AP - 27

RE: ABATEMENT PLAN AP-27 JUNCTION BOX E-15 SITE LEA COUNTY, NEW MEXICO

The New Mexico Oil Conservation Division (OCD) has reviewed Rice Operating Company's (Rice) March 31, 2003 "ABATEMENT PLAN AP-27, JUNCTION BOX E-15 SITE, BLINEBRY DRINKARD SWD SYSTEM, UL D&E, SEC 15, T22S, R37E, LEA COUNTY, NEW MEXICO". This document contains Rice's proposed work plan for additional monitoring wells to delineate the extent of ground water contamination related to Rice's Junction Box E-15 Site located in Unit D and Unit E of Section 15, Township 22 South, Range 37 East, Lea County, New Mexico.

Dote: 03-13-2003 Disk: KJG CD#3 - RC1522A.DWG Survey Date: 03-13-2003 Sheet 1 of 1 Sheets

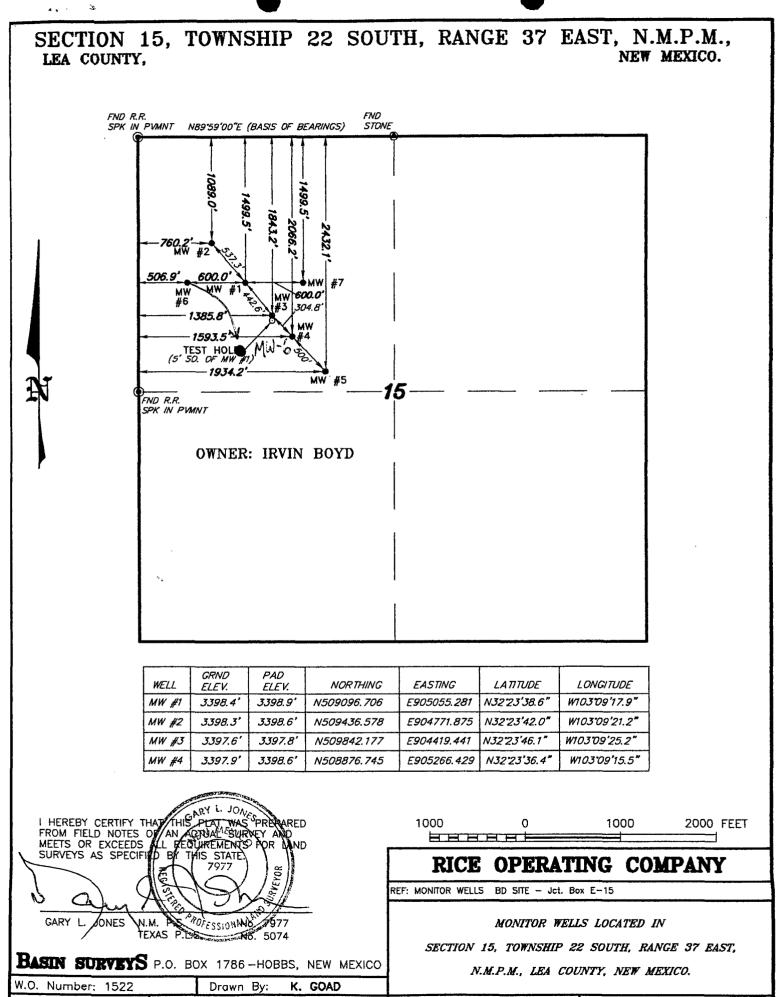
- 1. In order to determine the lateral extent of contamination hydraulically downgradient of the site, proposed monitor well MW-6 shall be relocated and installed in the approximate location shown on the attached figure.
